Minutes of the Regular Meeting of the Public Building and Site Commission held on Tuesday, August 22, 2017 at the Reed Intermediate School. Chairman Robert Mitchell called the meeting to order at 7:09 p.m.

**Monthly Report  
to the Public Building and Site Commission  
August 22, 2017**

# Newtown High School Auditorium Renovations State Project #097-CPPP

ELECTRICAL  
LIGHTING MAIN  
FLOOR PLAN

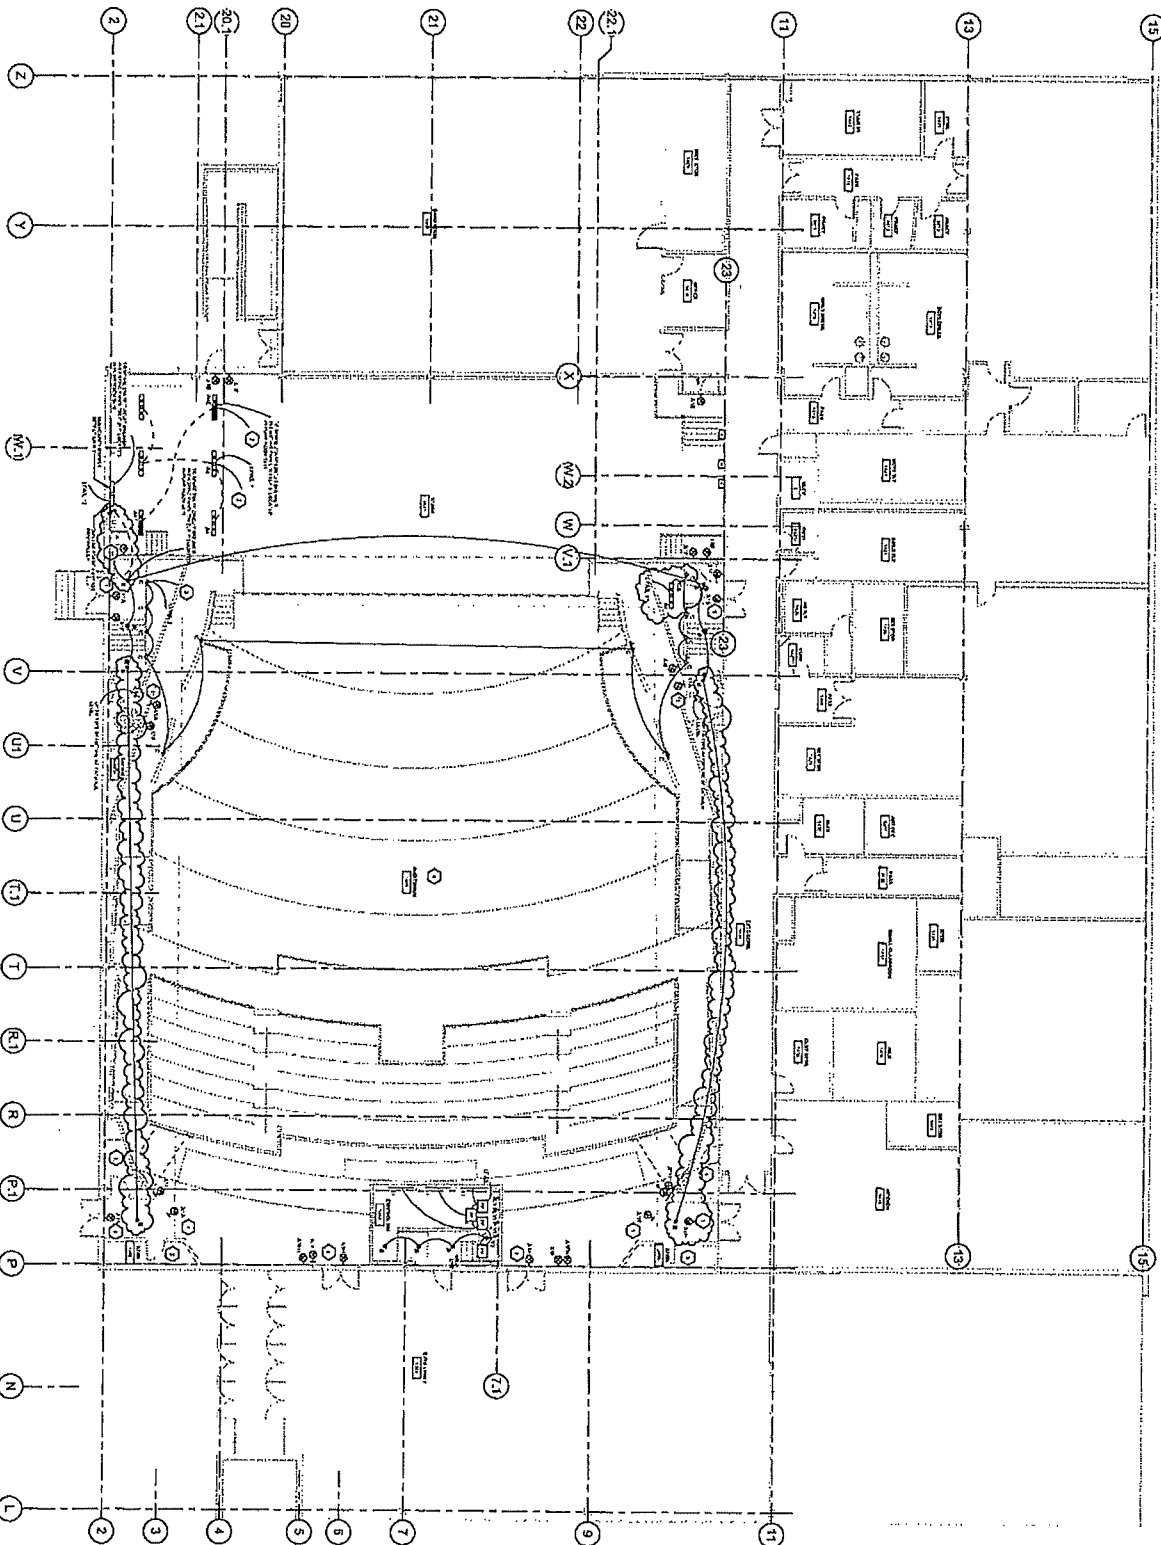
2. Provide new type B fixtures in existing recessed fixture locations and connect one fixture to the lighting circuit located in stair #2 and the other fixture to lighting circuit in stair 1. See attached revised drawing. Run the power through the DMX switching module to the dimmer switch and then to the fixtures. connect the 0-10V leads to the fixtures, dimmer to turn the lights off/on as well as dim them up/down. See attached cut sheet

- 3 Provide one type "A4" fixture, mounted to underside of ceiling. Wire through wall mounted toggle type switch adjacent to strike side of door. Wire to 20A-1P spare circuit breaker in panel "LPAS" with 2#12+1#12G,3/4"c. See attached revised drawing.

Per Discussion With Smith Edwards (1) A4 and (1) A4E  
Fixture Should Be Eliminated From The Western Most  
Catwalk Extension Shown On Bid Drawing EL1.02. Fixtures  
Should Be Used In AV1402 Per Item #3 Above Instead.

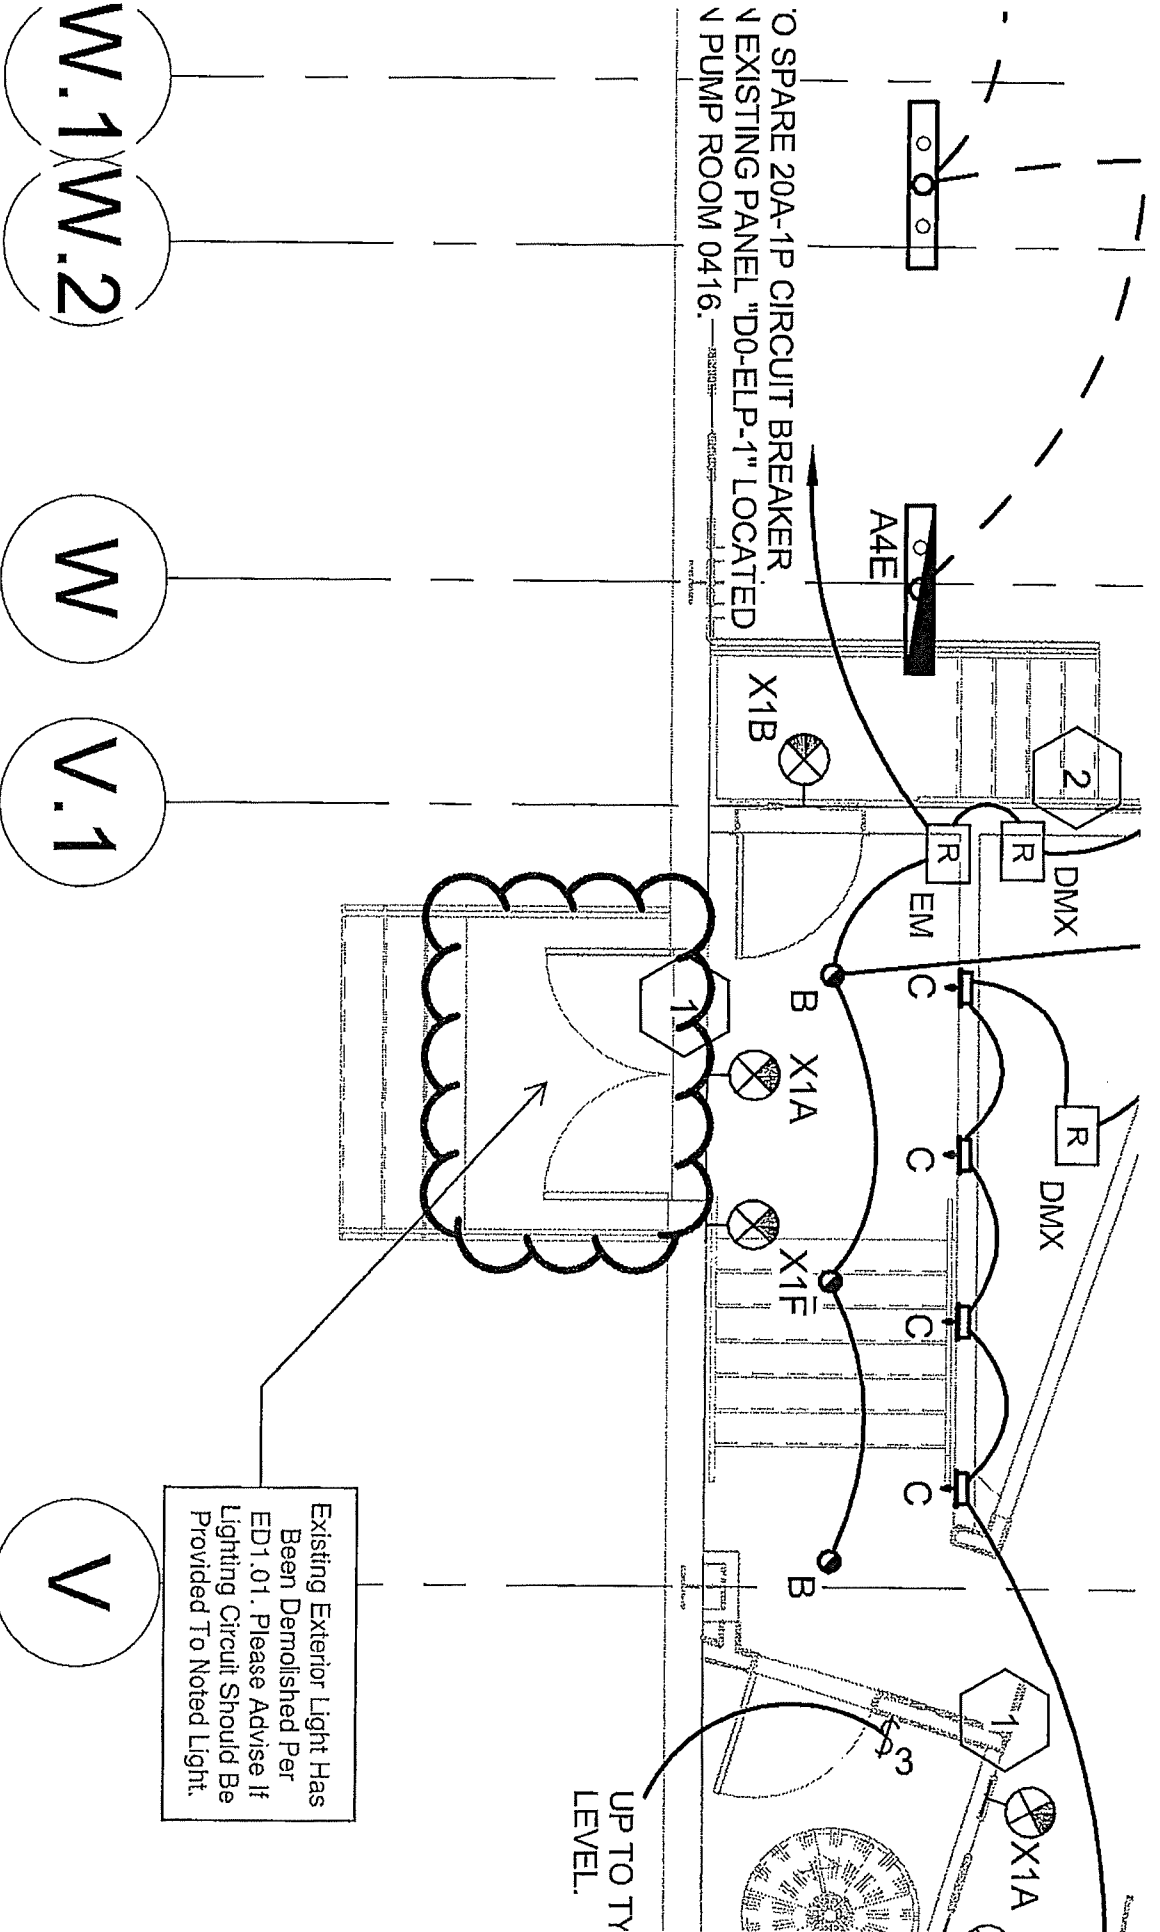
There is an exterior light located outside stairwell #1 that was tied into existing circuits that were demolished per drawing ED1.01. This light currently remains inoperable as is. Please see attached photos and advise if a new feed should be supplied to the light.

Connect existing exterior light located outside of stairwell #1 to existing wall pack located on the exterior of the south wall of the stage adjacent to the overhead door. Raceway and wiring to be run interior to wall pack location.

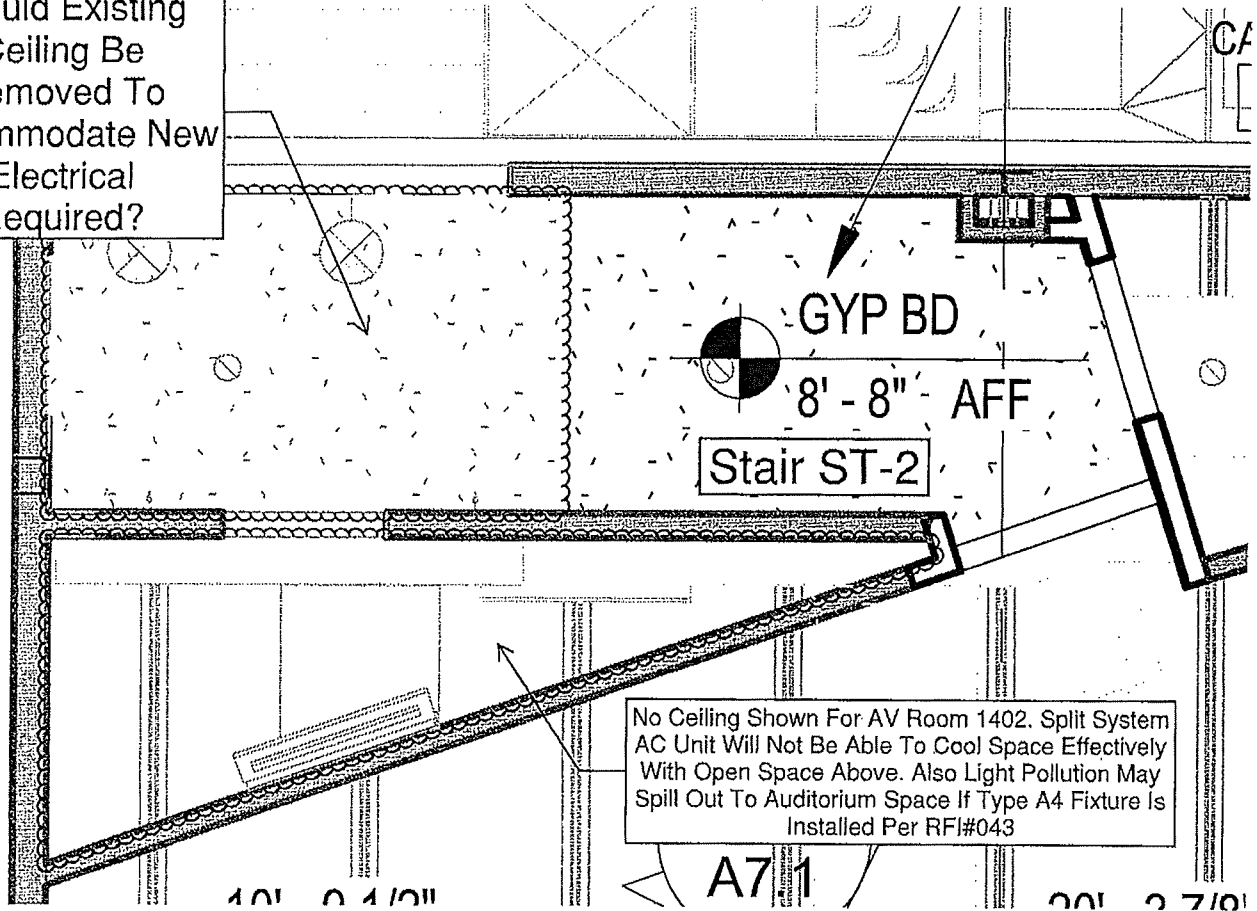
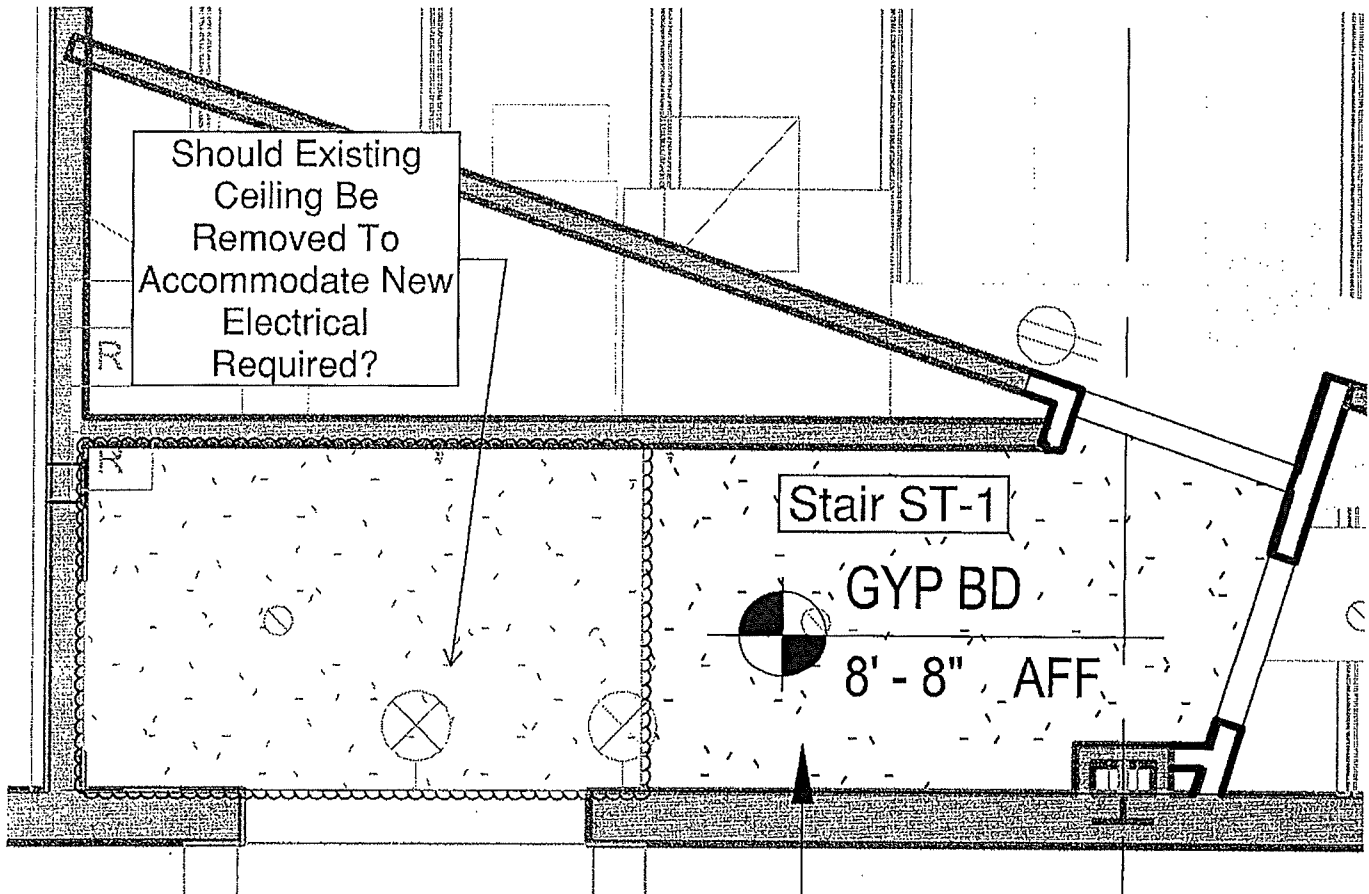
As seen on reflective ceiling drawing A2.1 a ceiling has not been called out for in AV Room 1402. The AC split system called for to condition the space will not be effective with an open space above. Also there is a possibility of some light pollution spilling over into the auditorium from the A4 fixture noted per RFI #043 response. Please advise if a ceiling should be provided within AV Room 1402. Also advise if adjacent existing to remain ceilings in stairwell ST-1 and ST-2 can be removed in order to access new electrical items shown to be installed. New recessed lighting and emergency lighting will need to be wired and mounted from above and existing fire alarm conduit interferes with new ceiling elevations which will need to be relocated to frame new ceilings at 8'-8" AFF. Some of these items cannot be accessed without placing large holes in existing drywall ceilings. It may be cleaner to replace old drywall with new.

Should Existing Ceiling Be Removed To Accommodate New Electrical Required?

1. PROVIDE A NEW 5/8" GYP. BD. CEILING SYSTEM IN 1402 AV ROOM. CEILING HEIGHT TO TOP OF CMU WALL (+/-8'-8"). MOUNT A4 LIGHT FIXTURE TO UNDERSIDE OF NEW CEILING (THIS SUPERCEDES RFI #043 RESPONSE).
2. WE TAKE NO EXCEPTION TO NEW CEILINGS PROVIDED THERE IS NO ADDITIONAL COST TO THE OWNER. MATCH EXISTING CEILING HEIGHT. MATCH EXISTING CEILING SYSTEM AT MINIMUM.

Stair  
ST-1

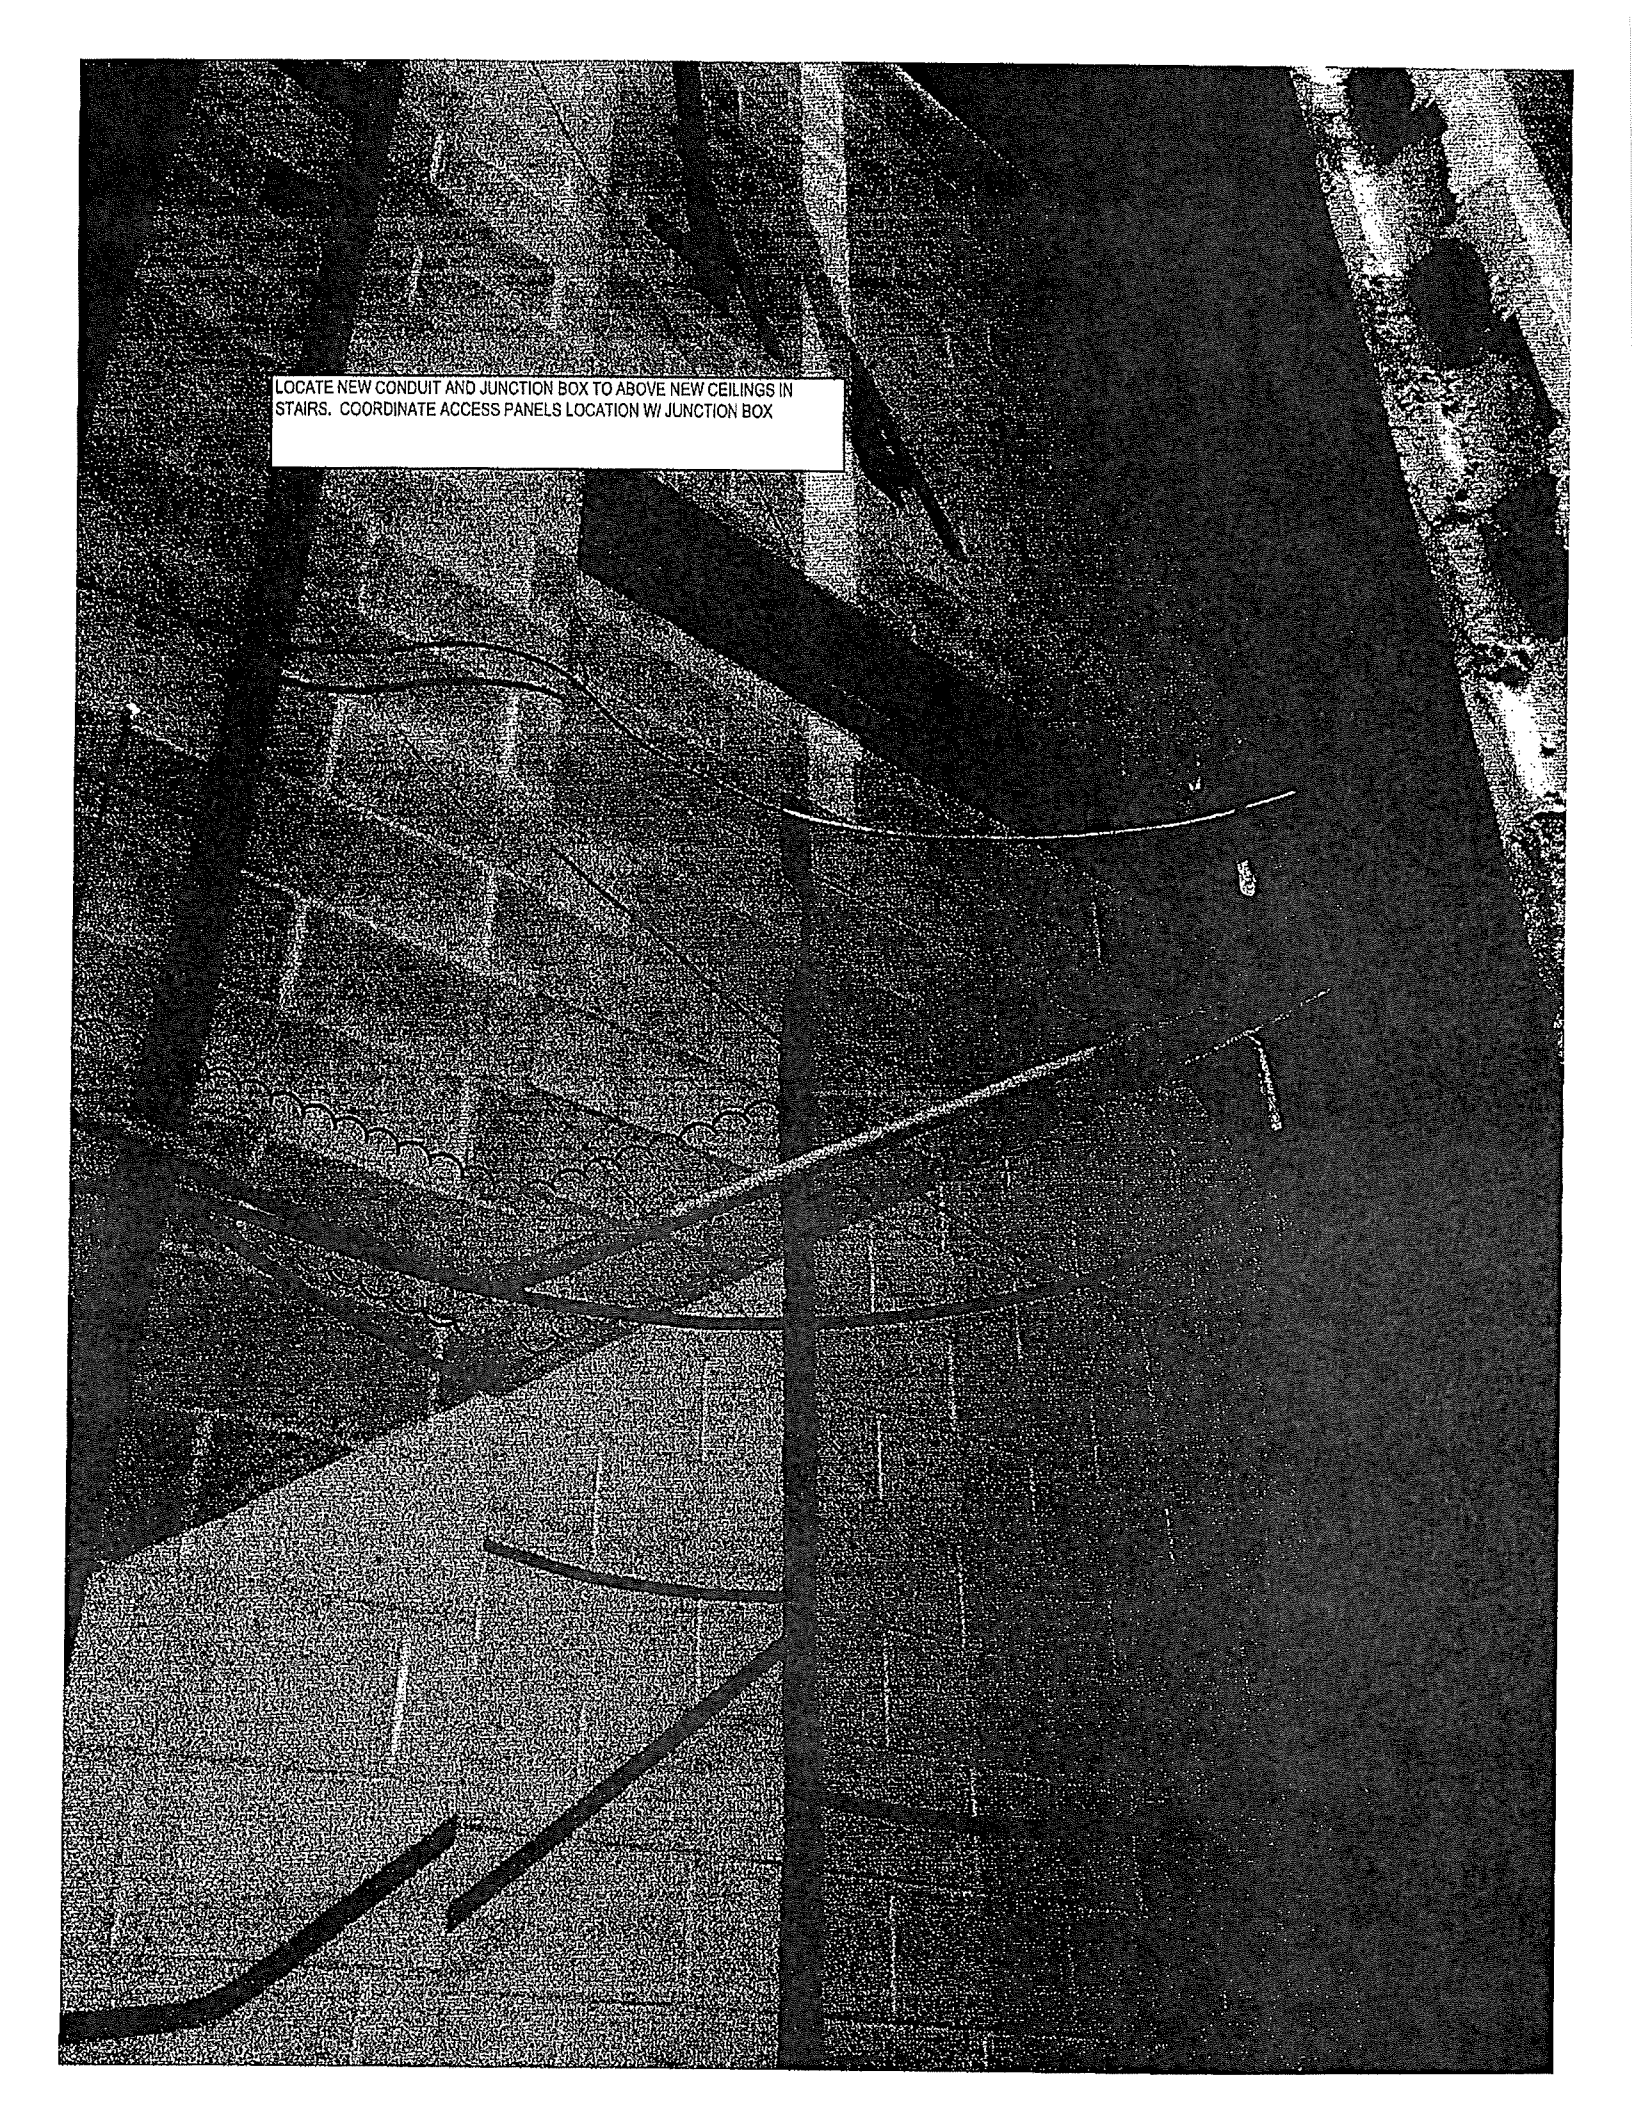
Existing Fire Alarm Conduit  
Interferes With New Ceiling  
Elevation. In Order To Access  
Conduit Access Above Ceiling  
Will Be Required.

Light Fixture To Be Replaced.  
Access Above Ceiling To  
Mount & Wire Unit Will Be  
Required.

New Emergency Light Fixture  
To Be Installed. Access Above  
Will Be Required.

LOCATE NEW CONDUIT AND JUNCTION BOX TO ABOVE NEW CEILINGS IN STAIRS. COORDINATE ACCESS PANELS LOCATION W/ JUNCTION BOX
